February 10, 2020

Re: Site C Clean Energy Project - Proposed Design Changes to Highway 29 Crossings at Farrell Creek, Dry Creek and Lynx Creek

Table 1. Proposed Revisions to EIS Section 4.3.4.1, Table 4.5

Figure 4.28 General arrangement of Highway 29 realignment segment at Lynx Creek			
Date	Nov. 23, 2012	DWG NO	1016-C14-B6158-14 R 0

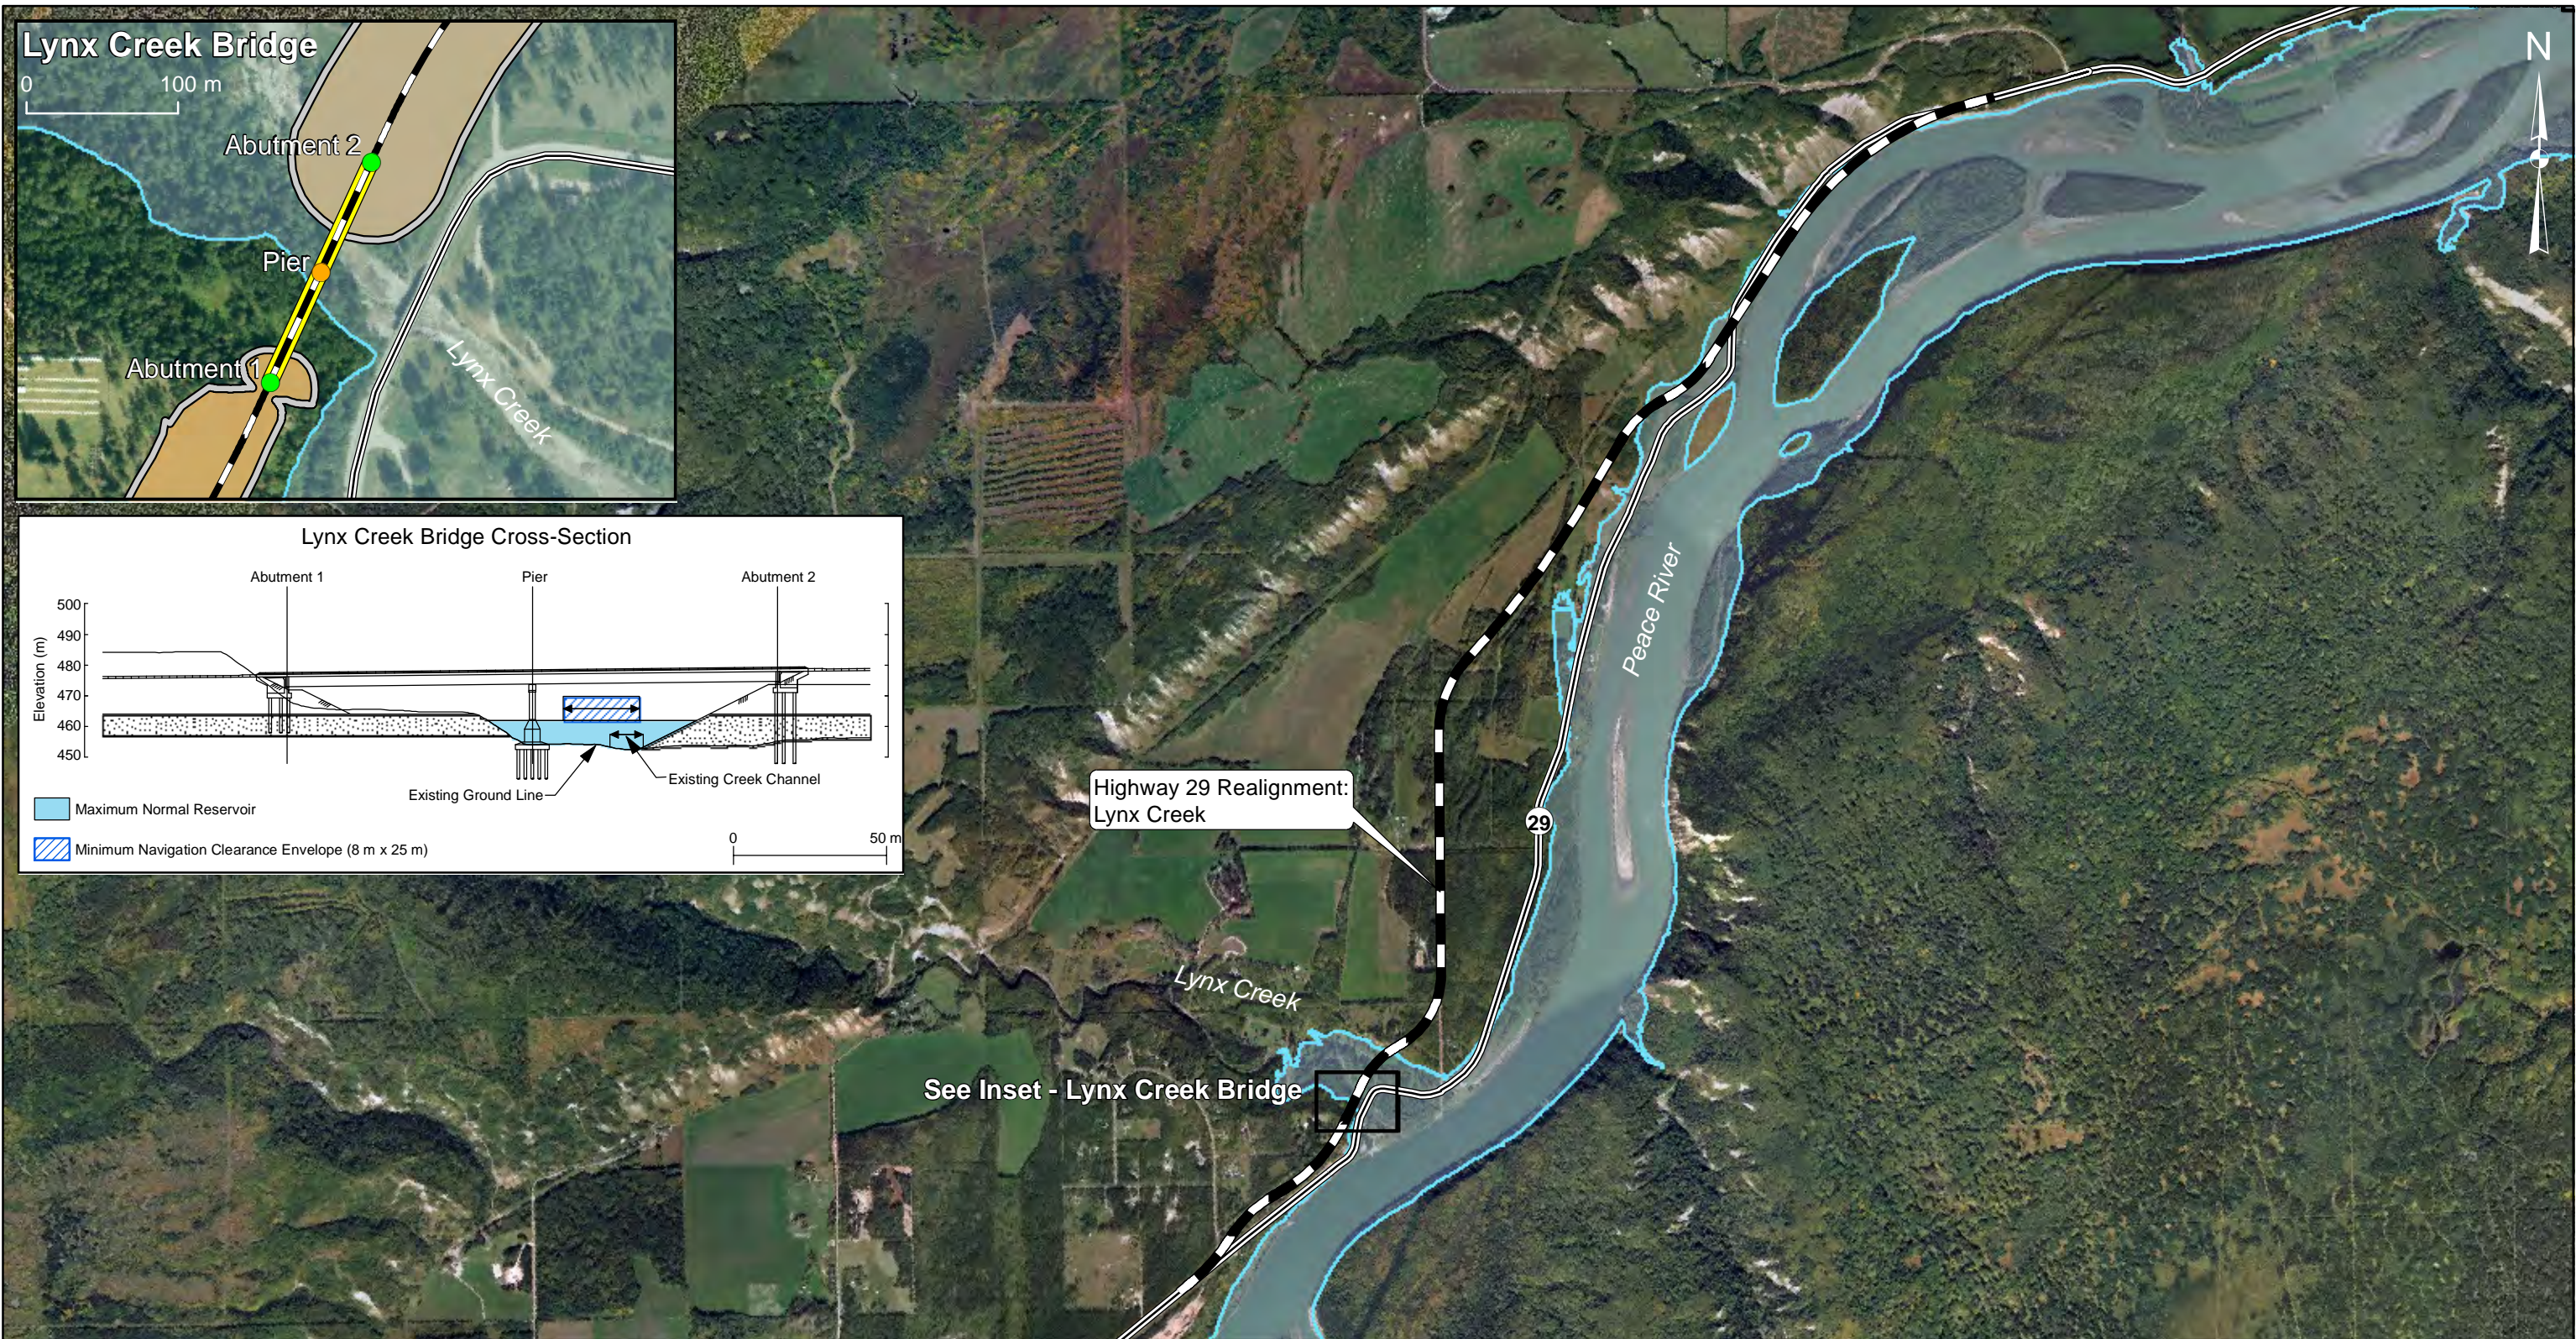
As shown in Figures 2, 3 and 6, the proposed design changes to the Lynx Creek crossing will not materially change the alignment of the crossing, with the proposed revised alignment a few degrees offset from the EIS alignment. The height of the causeway for the proposed revised crossing has been lowered, resulting in a design requiring additional excavation within the vicinity of the crossing. This excavation will take place within the area of disturbance as assessed for the EIS. In addition, this excavation would be used in the causeway construction, thereby reducing the need to haul material from external sources for construction.

Component	EIS Text	Proposed Revisions to EIS Text
Highway 29 Realignment Lynx Creek	Section 4.3.4.1, Table 4.5: Highway 29 Realignment Segments and Respective Watercourse Crossing Lengths For Lynx Creek: Total Length of Segment: 8.0 km Causeway Length: 290 m Bridge Length: 160 m Number of Piers: 1 Number of Bridge Spans: 2 Figure Number: Figure 4.28 Rev 0 (attached as Appendix C, Figure 2)	Section 4.3.4.1, Table 4.5: Highway 29 Realignment Segments and Respective Watercourse Crossing Lengths For Lynx Creek: Total Length of Segment: 8.0 km Causeway Length: up to 290 m Bridge Length: up to 180 m Number of Piers: up to 3 Number of Bridge Spans: up to 4 Figure Number: Figure 4.28 Rev 1 (attached as Appendix C, Figure 3)

Figure 5: Profile of Lynx Creek Bridge, per proposed revised design (not to scale)

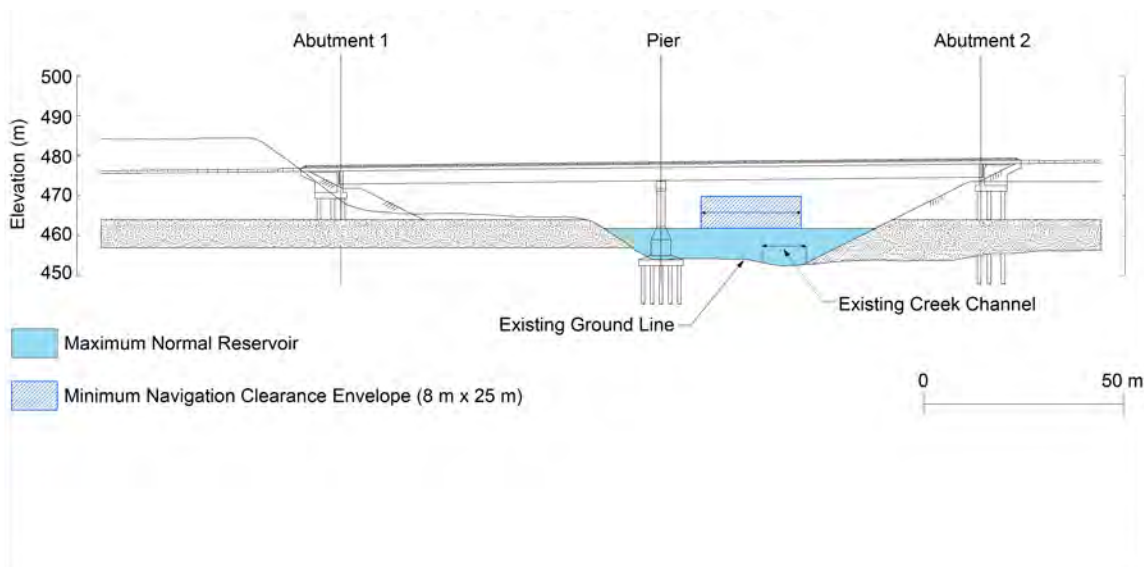
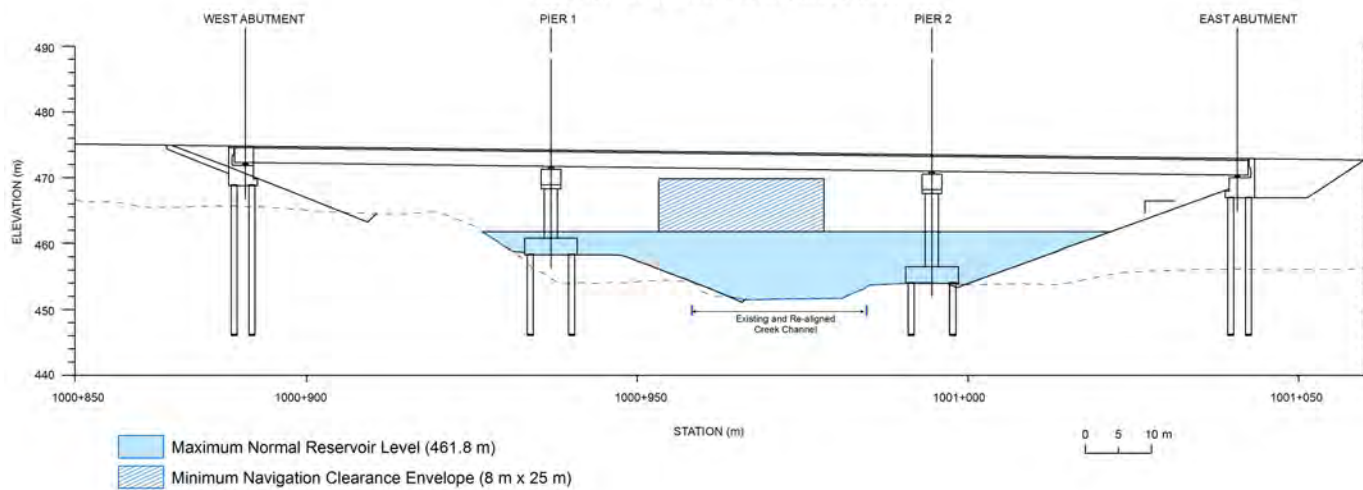
The assessment is supported by information in Figures 4 and 5 – the EIS and Revised Design bridge profiles -- and Figure 6, a plan view of the EIS bridge design versus the proposed revised design, post reservoir filling.

The proposed modification to the Lynx Creek Bridge design is not expected to result in any additional effects on navigation beyond those predicted in the EIS. The Lynx Creek Bridge design in the EIS includes a pier and a minimum navigation clearance envelope equal to 8m high (as measured from maximum normal reservoir elevation, 461.8m), and 25m wide. During the environmental assessment, Transport Canada provided an analysis that resulted in the recommendation that the Lynx Creek Bridge design contain a clearance envelope that is 8m high, as measured from the 461.8m reservoir elevation level, and 25m wide.⁸ The proposed revised bridge design meets these requirements.
